HISTORIC RESOURCE EVALUATION ASSESSMENT REPORT

Project: Assessment of proposed AC Marriott hotel at 3466 Mission Inn Boulevard, Riverside CA 92501 on an adjacent lot adjoining the Central Fire Station / Fire Station No. 1 structure at 3420 Mission Inn Avenue, with a planned future exterior façade rehabilitation and Adaptive Reuse project

Document issue 13 January 2021

Site context and archive reviews; Design Development concept reviews of the proposed hotel structure addition to the local Historic Districts and to the adjacent structure listed on the California Register.

3.5 Summary of City meetings review comments, historic structure and site treatment

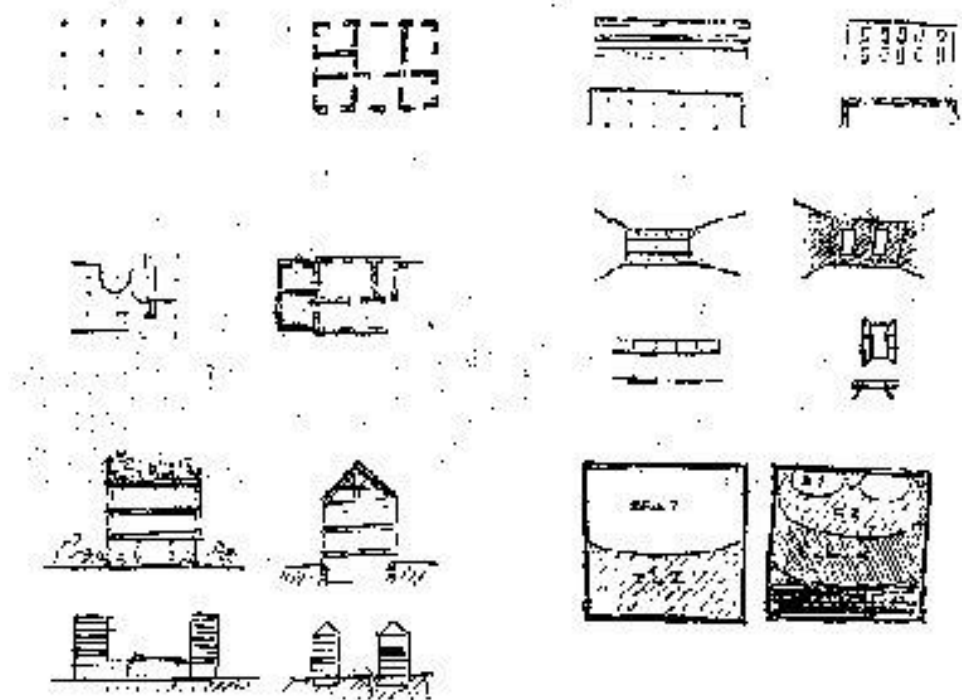
Pre-submittal Meetings with partial members of the Cultural Heritage Board and City of Riverside Community Development Department Planning Division were held during the development of the proposed AC Marriott/Residence Inn two-hotel property project. These meetings were very helpful and informative. A summation of review comments is provided:

3.5.1 Reviewed the proposed design consisting of two- brands of hotels: Residence Inn (extended stay) and AC Marriott (more of a boutique/ European / modern “design-led” influenced hotel.) Total number of rooms is 225.

3.5.2 Height of structure is proposed to be a combination of seven and eight floors, minimal floor to floor height, with four underground parking levels.

3.5.7 Initial design for building colors were considered to generally be too dark as and were subsequently revised, using lighter colors of browns, sepia browns, off white and cream colors; and specific reference to the existing brick color. Research into the original stucco color of Fire Station plaster façade will be made. A color strategy will be developed for review, including materials and textures.

▪ **4.5 Conclusions and Recommendations:**

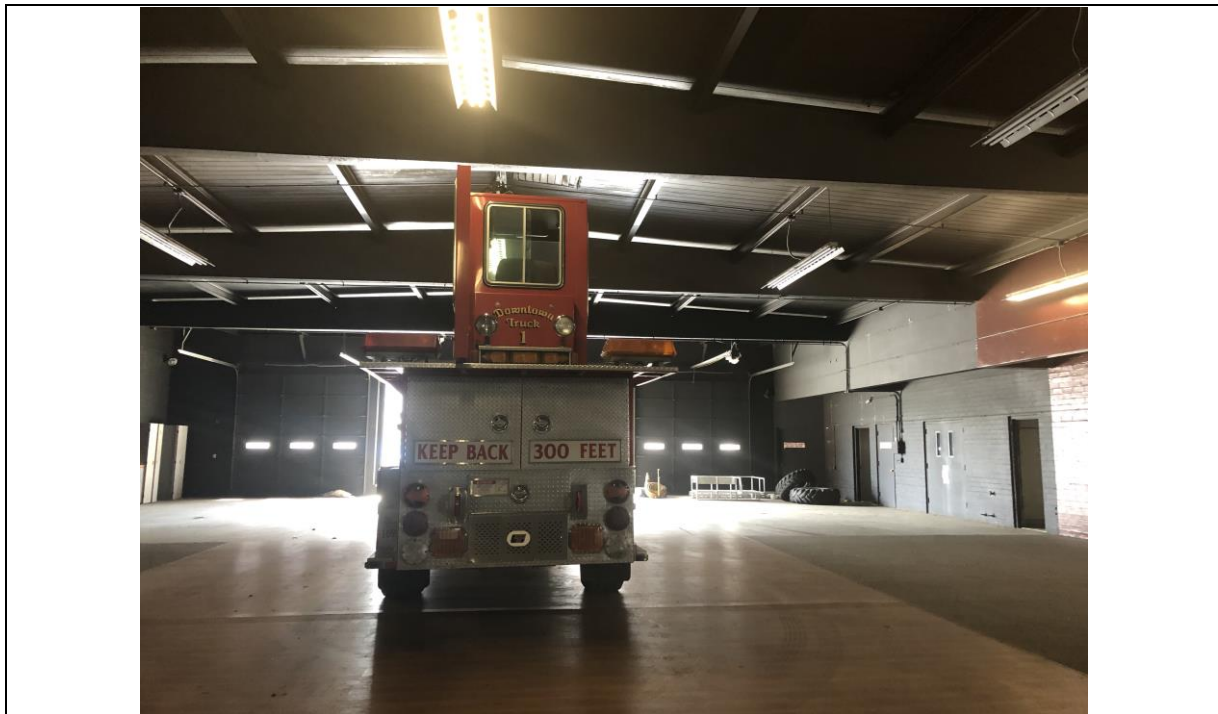
It is clear that there are some features in the Fire Station No. 1 structure that have suffered from combinations of factors. Multiple stages of infrastructural upgrades made over time have created an additive quality to some interior spaces and exterior surfaces. Some of these alterations are no longer functional or functioning as intended.

The present conditions with a lack of significance or deteriorated conditions indicates that original integrity is lacking at most interior spaces. The exterior north façade maintains limited integrity in the overall storefront design at the Fire House public entrance, and is the element recommended to be evaluated for repair or replacement in the proposed project design. The exterior roll-up Apparatus Room doors at the south and north façades are proposed to be replaced with sectional panel overhead doors, without change to the original opening sizes. This

detail is developed in the proposed exterior work of the adaptive reuse portion of the new hotel construction.

As the west façade portion of the original Fire Station No. 1 structure is proposed to be encapsulated in place, the remainder of the structural connections to it are proposed to be modified as a part of the new hotel structural design. Special care for the adequate bracing of the façade during construction, and the structural detailing necessary for its support and connection to the new structural design will be required.
